**TOWN OF NEWBURGH
PLANNING BOARD
TECHNICAL REVIEW COMMENTS**

PROJECT NAME: CBPS REALTY INC
PROJECT NO.: 21-13
PROJECT LOCATION: SECTION 34, BLOCK 2, LOT 29.1
REVIEW DATE: 30 JULY 021
MEETING DATE: 5 AUGUST 2021
PROJECT REPRESENTATIVE: LANC & TULLY ENGINEERS

RE: Application for Site Plan
CBPS Realty, LLC
NYS Route 32 – SBL: 34-2-29.1
Town Application # 2021-13

CONCEPTUAL SITE PLAN
PREPARED FOR
CBPS REALTY, LLC
TOWN OF NEWBURGH
ORANGE COUNTY, NEW YORK

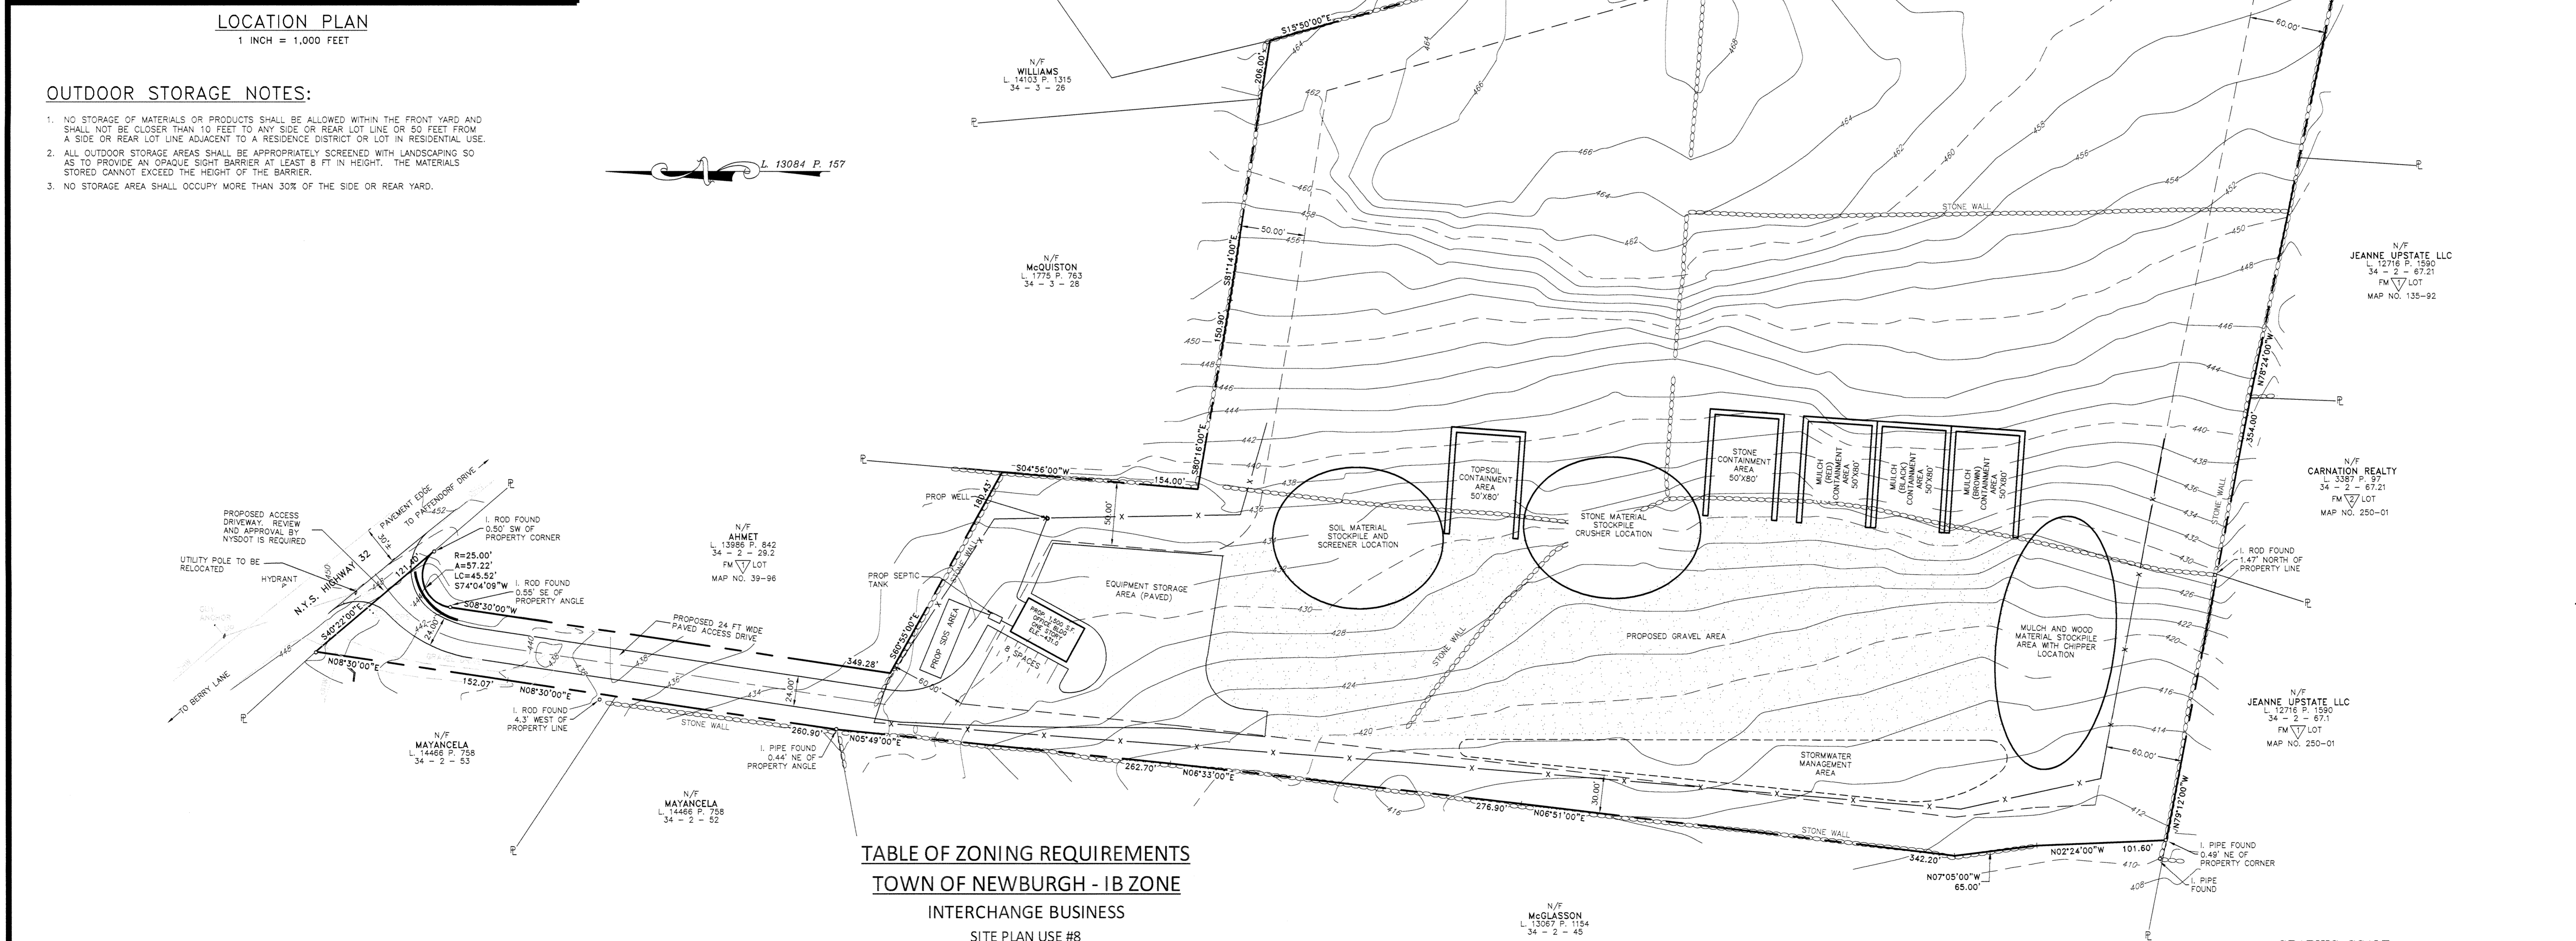
2. A proposed landscaping and privacy fence is identified on the plans. The fence appears to not enclose the eastern boundary of the proposed facility. If the project moves forward, we would recommend that the limits of disturbance be incorporated into the fenced area in order to control the use on the site.

8. The applicant's representative is requested to evaluate the grading of the storage/processing area. 10-feet of elevation difference exists across that area.
9. The applicants are requested to address the parking of vehicles not associated with the manufacturing use identified on the plans.
10. The Long Form EAF submitted identifies the site being within New York State Parks, Recreation and Historic Preservation's archeologically sensitive area. An archeological study should be provided.

2. Please refer to response to #1.
3. Notes have been added to Sheet 1 of the plans indicating the outdoor storage requirements.
4. The application will require OPRHP coordination will be required.

10. The site plan now indicates a fence line along the perimeter of the property. This will be refined within future submissions with landscaping and details to provide for the required buffer.
